भारत सरकार — रेल मंत्रालय
अनुसंधान अभिकल्प और मानक संगठन
लखनऊ — 226011
Government of India - Ministry of
Railways
Research, Designs & Standards
Organization, LUCKNOW - 226011

Modification Sheet No: RDSO/2009/EL//MS/0383 (Rev 0) – Oct'2009

Provision of LED indication near Q-50 relay for indicating status of C 145 contactor

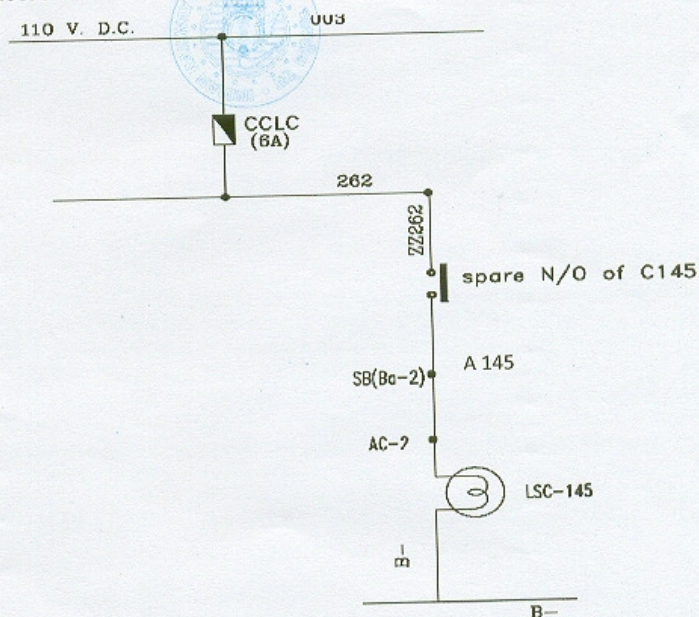
During traction mode C 145 should be in open position. When driver switches from dynamic braking to traction if C 145 does not open, Q 50 will not pick up thus preventing driver from taking notches. In this situation, driver is supposed to ensure correct position of CTF/J and C 145 before wedging Q 50. The correct position of CTF/J can be visually checked but C 145 cannot be checked without opening arc chute, and thus there is a possibility of driver wedging Q 50 even if C 145 is stuck up in close position and taking traction. This will cause short-circuiting of a part of winding of ATFEX and application of full voltage across remaining part of winding, which may lead to ATFEX burning. A few cases of burning of ATFEX with extensive damage in HT compartment have been attributed by ER to C-145 remaining closed and Driver wedging Q-50 relay and taking traction.

Therefore, Provision of a visual indication of the status of C 145 near Q 50 relay will help the driver to ascertain correct status of C 145 before wedging Q 50. Caution will be printed near Q-50 advising Driver not to wedge Q-50 in traction mode if LSC-145 is glowing. This modification does not interfere with the existing control circuit and reinforces the existing trouble shooting for LSB glowing, which includes checking of C-145 by the Driver. The modification has been tried by ER on 74 ASN base Locomotives

- (i) Single core elastomeric cable of size 3 mm²/ 750V, Qty. 10 Meters approx.
- (ii) Terminal socket (copper) – 3d x 5.2 mm², Qty. 07 Nos.
- (iii) Power LED (Red), 110V AC/DC, Qty – 02 No.(in parallel)
- (iv) Indication lamp fixing board (Insulated), Size 4 mm x 80 mm, Qty – 01 No
- (v) Location – Near Q 50 Relay.
- (vi) Caution board (insulated) with inscription "Driver not to wedge Q-50 in traction mode if LSC-145 is glowing ".Location near Q-50 relay

- (i) Connect a cable no. A145 in between spare terminal in SB (Ba-2) and spare N/O interlock of C 145.
- (ii) Connect another cable no. ZZ262 in between terminal in SB (Ba-2) with cable no. F262 and N/O interlock of C 145 against cable no. A145.
- (iii) Connect the cable no. A 145 with the terminal of LSC 145 via. SB (Ba-2) and SB (AC-2).
- (iv) A board for LSC 145 to be fixed near Q 50 Relay with the help of M.S. clamp.
- (v) Connect another terminal of LSC 145 with '(-) ve' cable.
